To:	Daniel Jacobs	From:	Drainage Team
------------	---------------	--------------	---------------

Planning App Ref:	PL/2026/01377
Service Ref:	Drainage
Date:	2/04/2026

Full planning permission for proposed rear extension, rear porch and lean to store.

The Old Post Office, The Street, Chilmark, Salisbury, SP3 5AR

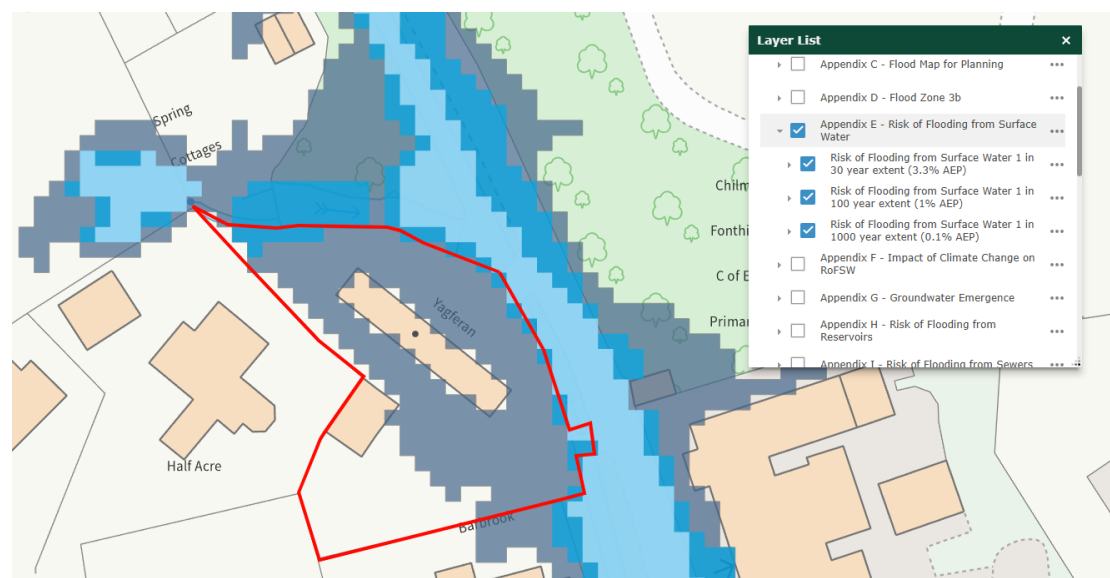
The Wiltshire Council Strategic Flood Risk Assessment, [SFRA Data Explorer](#), has indicated that the proposed site is located within Flood Zone 2 and has a high level of risk from fluvial flooding.

The site has a low level of risk from surface water flooding up to the 1 in 100 year rainfall event, but the majority of the site is at risk of surface water flooding during the 1 in 1000-year event.
